SIB 61 06 15

## Washer Fluid Reservoir Rattles While Driving on Rough Roads

This Service Information Bulletin (Revision 5) replaces SI B61 06 15 **dated November 2021**.

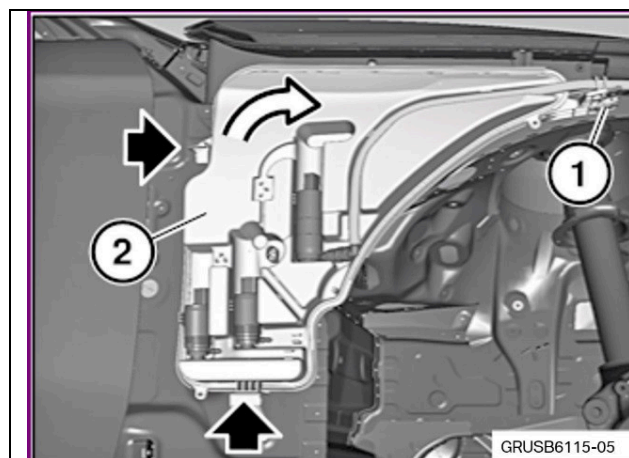
The windshield washer reservoir upper plastic locating guide tab has too much lateral play.

**Note: The close-up picture shows a gap (0.40 mm) that exists between the plastic reservoir guide and the metal securing bracket.**

Apply a piece of self-adhesive felt tape to the upper plastic locating guide of the washer fluid reservoir.

7. Prepare a piece of felt tape (80 x 60 x 1 mm) and apply it to the guide tab in the area shown.

8. The felt tape will eliminate the rattling noises coming from the metal bracket which can transmit into the glove compartment area. Reinstall the removed parts in the reverse order of their removal.
